An
Bord
Pleanála

FSC Report

ABP 309703-21

Construction of three residential blocks and alterations to existing basements – Blocks U, T and W, Charlestown Development, St. Margaret's Road, Finglas, Dublin 11

Figure 2 from JGA CFD Report P1/1376/9 Issue 2

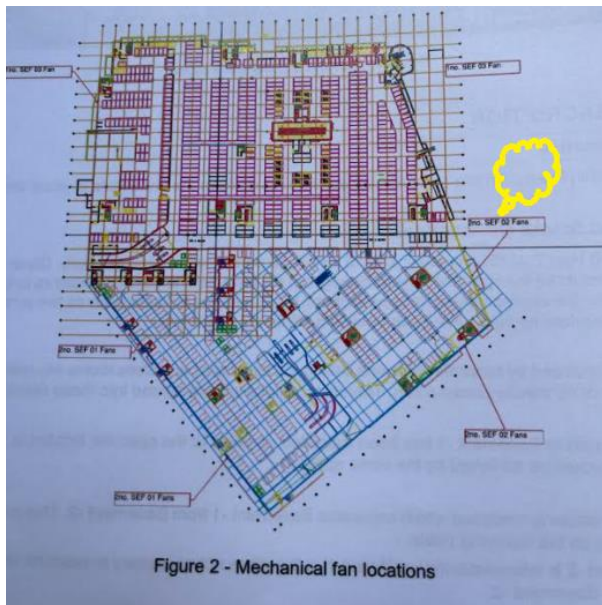
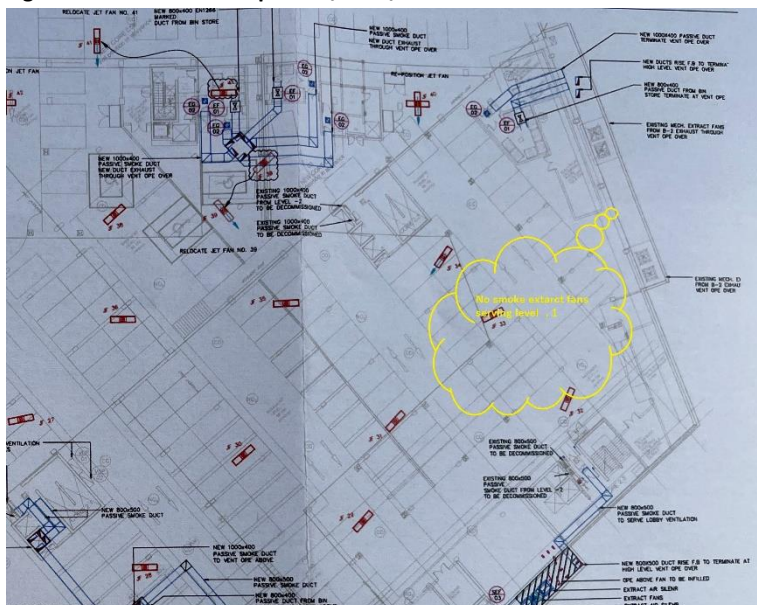
Furthermore it is noted that JGA indicate the presence of 2 x SEF 02 serving Level -1 in Figure 2 of their report which are not shown on the corresponding M&E drawing which they include with their appeal – refer copy extracts below.

- d. There is an anomaly between the Smoke Extract Fans (i.e. 2 x SEF 02) shown in the CFD report and on the VMRA drawings as noted in 2.1 above – which suggest that more fans may have been used in the CFD analysis than is provided for in the VMRA services drawings
